MARK	DATE	REVISIONS	BY	CH'D	CCO#
1	08/08/11	W2 DUCT BANKS REINFORCEMENT	MG	RG	205

CONTRACT CHANGE ORDER NO._____
SHEET _____ OF _____

UTILITY PLAN

DETAILS
UTILITY PLAN
DUCT BANK PROFILE

DETAIL 1

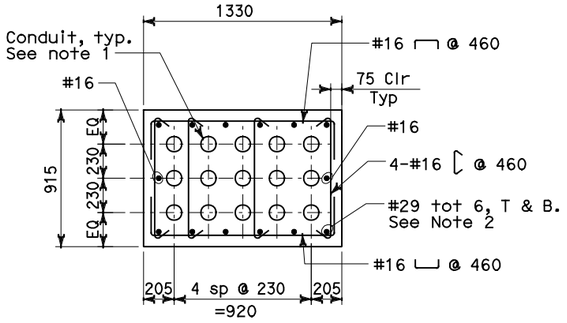
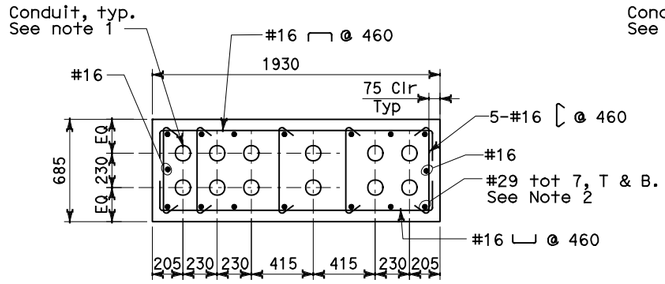
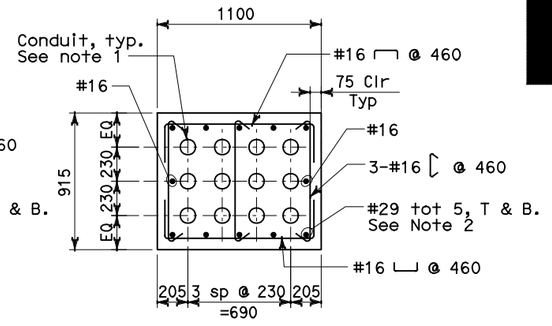
Note:
For Detail not noted or shown
see Section T-T on sheet E-19

Note:
For Detail not noted or shown
see Section U-U on sheet E-19

Note:
For Detail not noted or shown
see Section V-V on sheet E-19

Notes:
A. For Detail not noted or shown
see Section X-X on sheet E-19
B. Locate 1st stirrup 75mm from
face of pier.

Notes:
A. For Detail not noted or shown
see Section X-X on sheet E-19
B. Locate 1st stirrup 75mm from
face of pier.

1. For conduit duct bank sections, see sheet E-19, E-19A, E-19B and E-19C.
2. Where duct banks intersect, develop #29 top and bottom reinforcing a minimum distance of 1525 mm into adjacent duct bank.
3. The duct bank concrete compression strength at 28 days: f'c = 25 MPa.
4. The duct bank reinforcing bar yield strength: Fy = 414 MPa.
5. The duct banks have been designed for a maximum point load of 1330 kN distributed over a 1000mm x 1000mm area at the finished grade elevation.

DETAIL 7
SCALE: 1:20

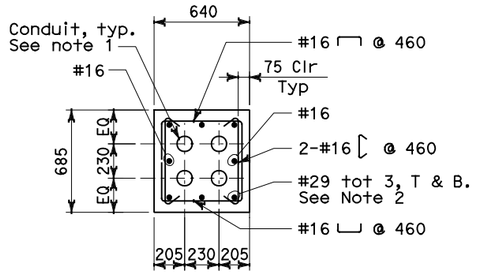
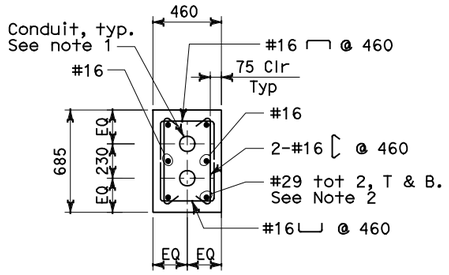
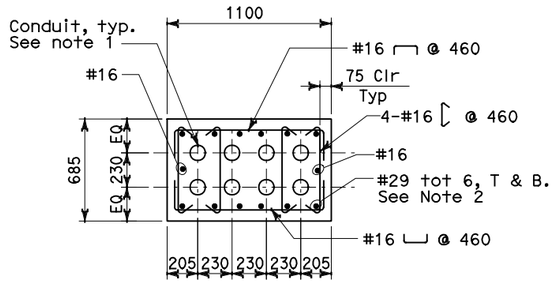
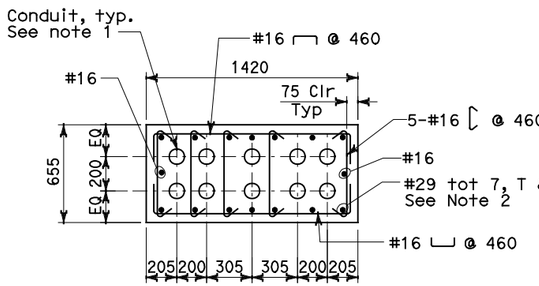
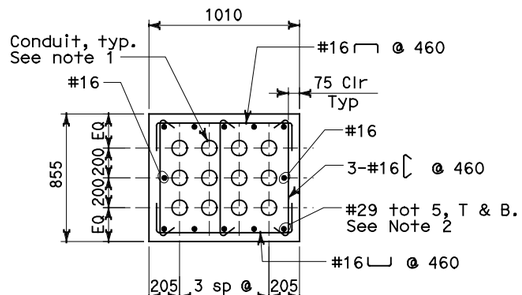
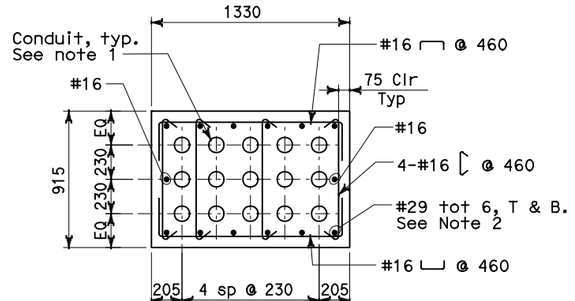
Note:
For Detail not noted or shown
see Section Z-Z on sheet E-19

Note:
For Detail not noted or shown
see Section Z-Z on sheet E-19

Note:
For Detail not noted or shown
see Section FF-FF on sheet E-19A

Note:
A. For Detail not noted or shown
see Section VV-VV on sheet E-19A.
B. Locate 1st stirrups 75mm from
face of pier.

Note:
A. For Detail not noted or shown
see Section VV-VV on sheet E-19A.
B. Locate 1st stirrups 75mm from
face of pier.

Note:
For Detail not noted or shown
see Section XX-XX on sheet E-19A

1. For conduit duct bank sections, see sheet E-19, E-19A, E-19B and E-19C.
2. Where duct banks intersect, develop #29 top and bottom reinforcing a minimum distance of 1525 mm into adjacent duct bank.
3. The duct bank concrete compression strength at 28 days: f'c = 25 MPa.
4. The duct bank reinforcing bar yield strength: Fy = 414 MPa.
5. The duct banks have been designed for a maximum point load of 1330 kN distributed over a 1000mm x 1000mm area at the finished grade elevation.
